Braidwood Station, Units 1 and 2
Facility Operating License Nos. NPF-72 and NPF-77
NRC Docket Nos. STN 50-456 and STN 50-457

Byron Station, Units 1 and 2
Facility Operating License Nos. NPF-37 and NPF-66
NRC Docket Nos. STN 50-454 and STN 50-455

Subject: Additional Information Supporting Request for License Amendment Regarding Measurement Uncertainty Recapture Power Uprate

**RESPONSE TO REQUEST FOR ADDITIONAL INFORMATION (RAI)
February 20, 2012**

Figure EMCB R4 - 1: Bottom Portion of Integrated Head Package to Reactor Vessel Closure Head

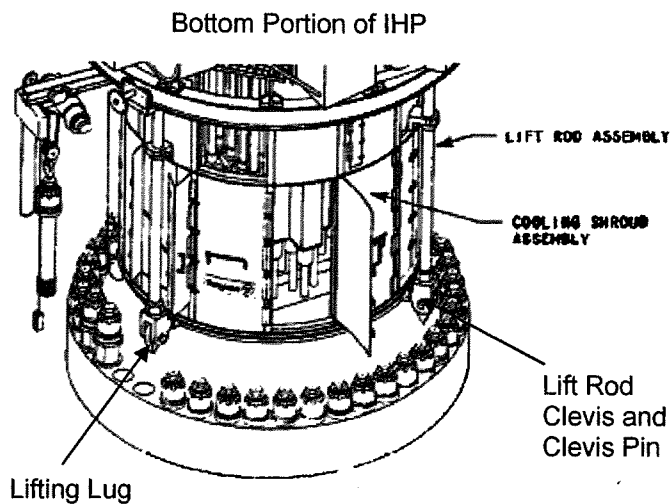
Furthermore, the lifting lug loads and evaluation are discussed in Section IV.1.A.i of Attachment 7 to the LAR. The terminology of "lifting lug" and its relation to and its inclusion in the proposed MUR power uprate license amendment is not clear. Provide further information to clarify which

reactor vessel component is referred to as "lifting lug". Also, regarding the affected reactor vessel component,

There are three lifting lugs oriented 120° apart around the external side of the reactor vessel closure head. The Integrated Head Package (IHP) lift rod assemblies attach to the lifting lugs through a lift rod clevis and clevis pin. Figures EMCB R4-1 and R4-2 depict how the lifting lugs are attached to the reactor vessel closure head.

The lifting lug mechanical loads identified for current operating conditions did not change due to the MUR power uprate.
